**WATTS BAR NUCLEAR PLANT (WBN) - UNIT 2 – WESTINGHOUSE EAGLE-21  
PROCESS PROTECTION SYSTEM (TAC NO. MD6311)**

**Enclosure 1**  
**WBN Unit 2 Eagle-21 Request for Additional Information**

Figure 1

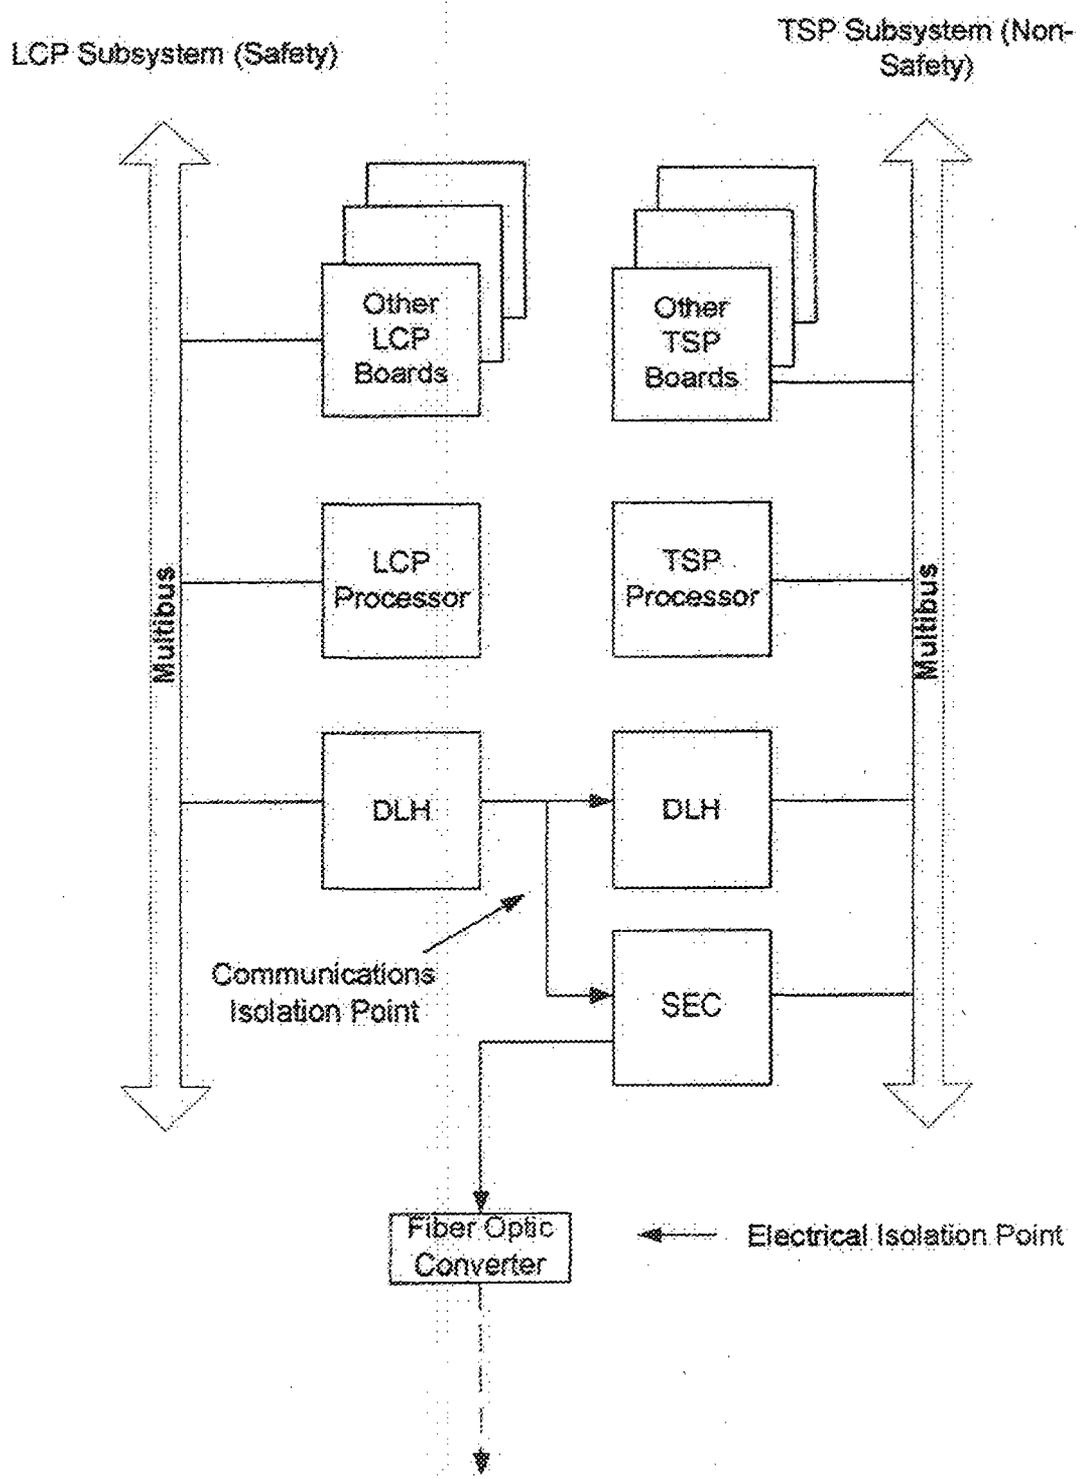
***NRC Question 1:*** *On page E1-1 of Enclosure 1 to the February 28, 2008 letter, TVA stated that an external interface was added that included a serial-to-ethernet controller board in each Eagle-21 multibus chassis. TVA further stated that it is not possible for the nonsafety-related integrated computer system signals to feedback to the safety related Eagle 21.*

*Has this addition and the associated changes been tested to prove this statement? If so provide the test procedures and test results.*

**TVA Response:** A test to confirm that data cannot propagate from the non-safety Plant Integrated Computer System (ICS) link to the safety portion of the Eagle-21 system was not performed. The rationale is that it is physically impossible for such a propagation to occur. The Serial Ethernet Controller (SEC) board which interfaces with the ICS link receives data by passively listening (i.e., receive only, no handshake) to the Loop Control Processor (LCP) (safety portion of system) to Test Sequence Processor (non-safety portion of system) datalink. The LCP Datalink Handler card which is transmitting the message is a one-way, broadcast communication link and has no receive capability. The SEC board only uses the Multibus bus connection for power and is installed in the non-safety tester portion of the Eagle-21 system. Thus there is no data connection that would allow data transmission between the non-safety ICS link and the safety portion of the Eagle-21 system. The design meets the requirements of IEEE Std 7-4.3.2-1993, "IEEE Standard Criteria for Digital Computers in Safety Systems of Nuclear Power Generating Stations," Annex G, for safety to non-safety communications. Figure 1 shows the electrical and communication isolation points.
